The Horns Public House

HERITAGE IMPACT ADDENDUM

Document No: 1320-HR-A-TP-XX-0002

- 1.1 This Addendum is submitted to summarise responses pertaining to comments received 31.01.2025 from the Built Heritage Officer for Wokingham Borough Council (WBC) regarding application 242954 *“Application for Listed Building consent for the proposed external alterations to the building, including changes to fenestration and erection of a single storey canopy roof to the side; internal refurbishment of the bar area; removal of 3 no. chimney breasts at ground floor and associated structural works; structural works to the existing ground floor timber frame and 1 no. ground floor chimney, toilets and first floor rooms; new signage to the main elevation and a replacement roadside post sign.”*

PHOTOGRAPH 1.

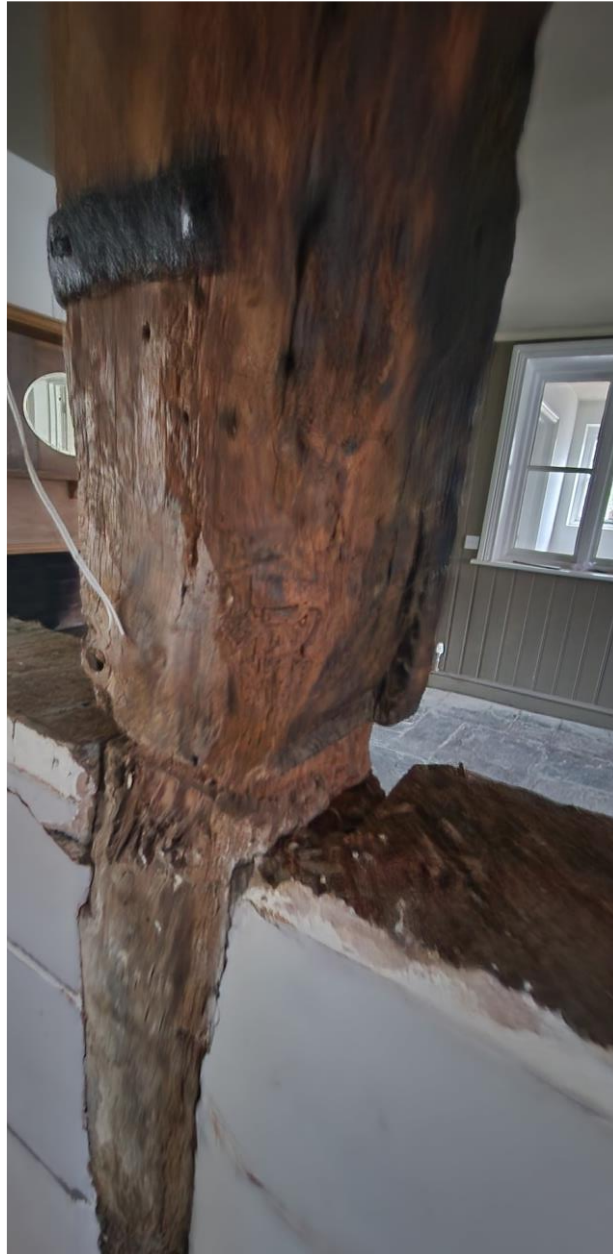
To the left-hand side sections of the original beams have been removed in the past, which is now partially supported by a modern-day timber post (built only off the existing timber floor) and a section of timber coach screwed to the original post. The cross-sectional area of this original post has been greatly reduced by two thirds by stitch drilling in the past which we believe may have been for cabling. (Refer to photographs 1 & 2.)

To enable this system to be installed it does require that the original top timber beam is notched to allow the steel post to connect to the steel beam. The only possible alternative to this would be to remove the entire wall / frame and rebuild it like for like in new oak timbers, or alternatively to use the steel beam as specified but remove the end post and replace this with a new steel column.

We feel however that the original wall / frame should be retained and that with careful notching to the original timber beam to enable the steel post to be inserted, would be a less intrusive solution to the historic fabric of the building.
